Access Compliance Report

Public Rights-of-Way

(Curb Ramps)

Intersection ID: 14078	Main Street: EAST_BV	Cross Street: SOUTH_BV	Location:	N
ADA ID: 30385719858D	Ramp Type: Perp	Initial Pass/Fail: Fail	Overall Compliance: No	Severity Score: 25
Codes/Mitigation Info/Possible Solution		Field Measurements/Component Compliance

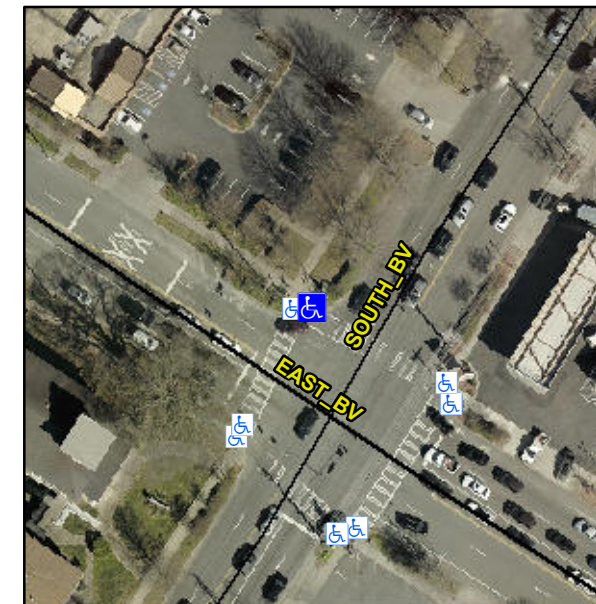
Not Found, R304.5.3

Compliance	Description	Data	Compliance	Description	Data
N/A	Ramp Length (in)	43.0	Yes	Ramp Slope (%)	5.2
Yes	Ramp Width (in)	48.0	No	Ramp XSlope (%)	8.9
N/A	Flare Type LT	N/A	N/A	Flare Type RT	N/A
N/A	Flare Slope LT (%)	N/A	N/A	Flare Slope RT (%)	N/A
N/A	Flare Traversable LT?	N/A	N/A	Flare Traversable RT?	N/A
N/A	Landing Length (in)	N/A	N/A	DWS Provided?	N/A
N/A	Landing Width (in)	N/A	N/A	DWS Contrast?	N/A
N/A	Landing Slope (%)	N/A	N/A	DWS Length (in)	N/A
N/A	Landing X Slope (%)	N/A	N/A	DWS Full Width?	N/A
N/A	Landing Curb? (Y/N)	N/A	N/A	DWS Offset (in)	N/A
N/A	Shared Landing?	N/A			
N/A	Gutter Ponding?	N/A	N/A	Gutter Slope (%)	N/A
N/A	Gutter Lip Ht (in)	N/A	N/A	Gutter X Slope (%)	N/A
N/A	Painted X Walk1?	Yes	N/A	Painted X Walk2?	N/A
	X Walk 1 Direction	To SE		X Walk 2 Direction	N/A
N/A	X Walk 1 Width (in)	109.0	N/A	X Walk 2 Width (in)	N/A
	X Walk 1 Slope (%)	6.4		X Walk 2 Slope (%)	N/A
	X Walk 1 X Slope (%)	1.0		X Walk 2 X Slope (%)	N/A

Remove & Replace Entire Ramp.
